PROJECT	TITLE	SIZE	STATUS
3-9 Grosvenor Road, Wrexham, LL11 1DB	Proposed Building Elevations	A1	CONSTRUCTION
Sheet 1			
PROJECT No. 1449	DRAWING No. L020 J		
DRAWN BY: AJS	CHECKED: AJS		
DATE: Jul 2015	SCALE (1:100)

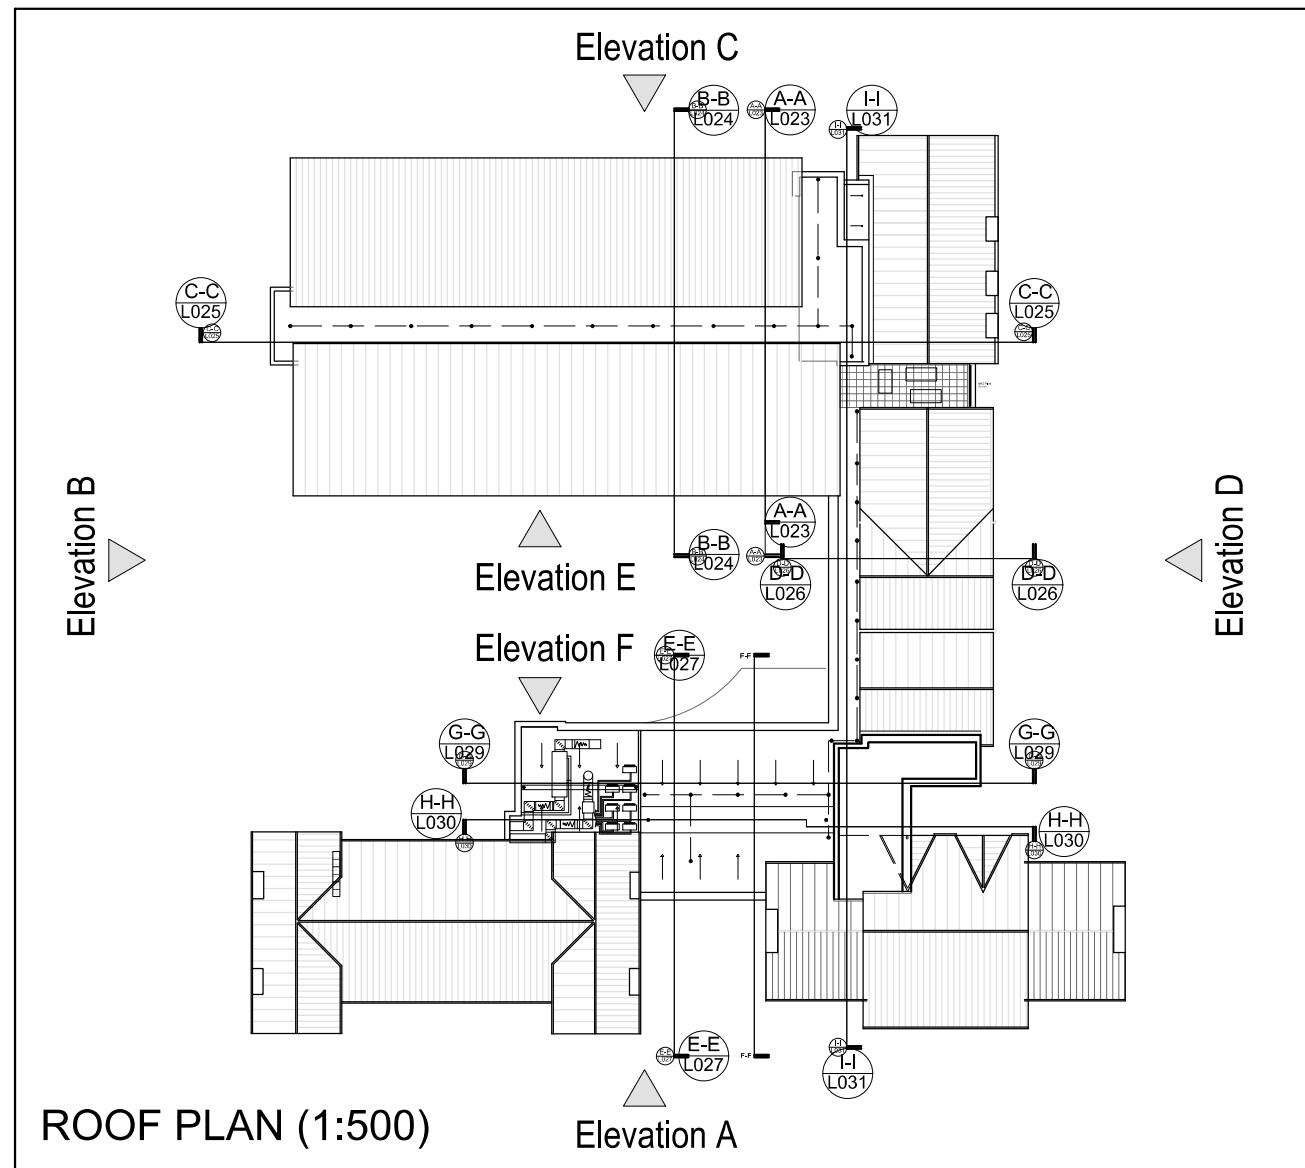
Rev J Glazing bars to timber windows removed as per conservation officers approval
Rev H Windows within clouds on elevation B relocated as per fusion fire report
Rev G Elevation B updated, WF 31 head height amended to suit eaves level
Rev F DLG.01, WG.16 & WF.17 width increased to 1250mm as per window manuf request
Rev E Status amended, window fenestration amended, notes added
Rev D Tandem parking to elevation B added
Rev C AOV location identified
Rev B Zinc finish amended, minor elevational amendments
Rev A Drawing amended as highlighted
